# M4 Corridor around Newport

Stage 1 Road Safety Audit  
Exception Report

M4CaN-DJV-GEN-ZG\_GEN-RP-CH-0006

P03 | 7 December 2016

### PROBLEM 59

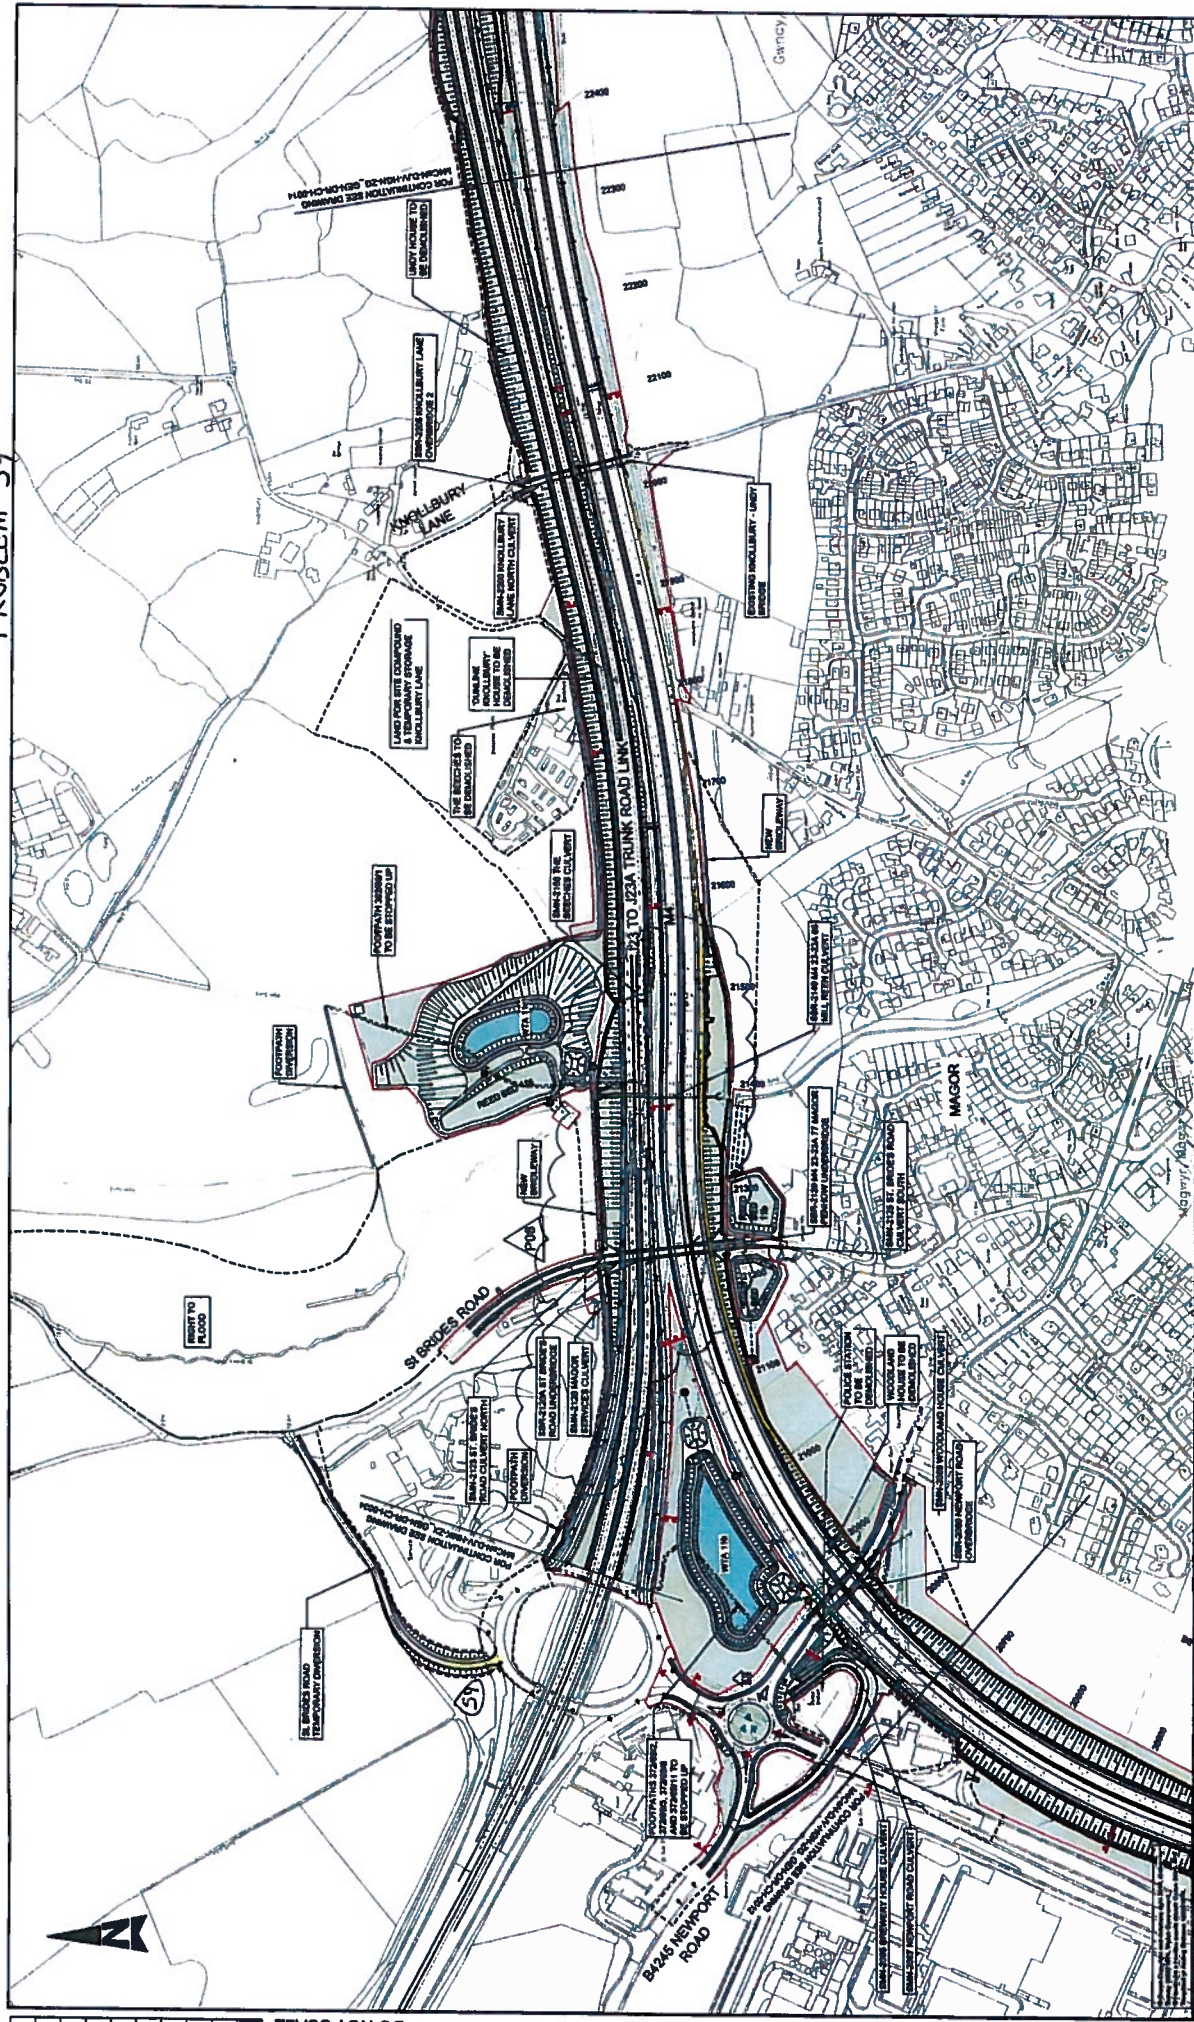
The proposed temporary diversion of St Brides Road would add an additional arm to the existing J23a. The visibility from this arm appears constrained from the drawing, and there were relatively high circulatory speeds observed during the site visit. The RSA Team is concerned that an additional arm at this location could result in side swipe collisions.

I agree with the Design Team and consider the Road Safety Audit Recommendation to provide an alternative temporary diversion route for St Brides Road to be not viable or proportionate.

I propose that the Recommendation to provide an alternative temporary diversion route for St Brides Road, as suggested in Problem 59 in the Stage 1 Road Safety Audit, is not implemented. I proposed that the Design Team's alternative proposal to further develop the temporary layout and traffic management during detailed design to maximise visibility, minimise circulatory speeds and accommodate NMUs is implemented instead.
